AMENDMENTS TO THE DRAWINGS

Please substitute the enclosed sheets 2/7 and 6/7, labeled “Replacement Sheets,” for the corresponding sheets presently in the case. Also enclosed, labeled Annotated Marked-up Drawings, are marked-up copies of each Replacement Sheet indicating the changes.

ANNOTATED MARKED UP COPY

FIG. 8

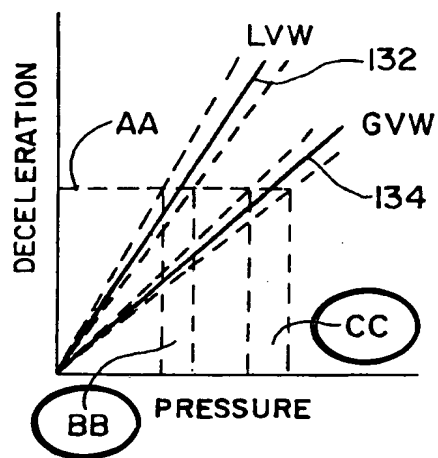
An objection was made to the use of reference letters “B” and “C”. Fig. 8 is amended to designate regions BB and CC, it being noted AA was changed by previous amendment.

The specification is amended at page 15 to clarify that the RPC controller is ECU 70 in the described embodiment, and at page 19 to refer to AA, BB and CC in Fig. 8, consistent with the amendments to the figure.
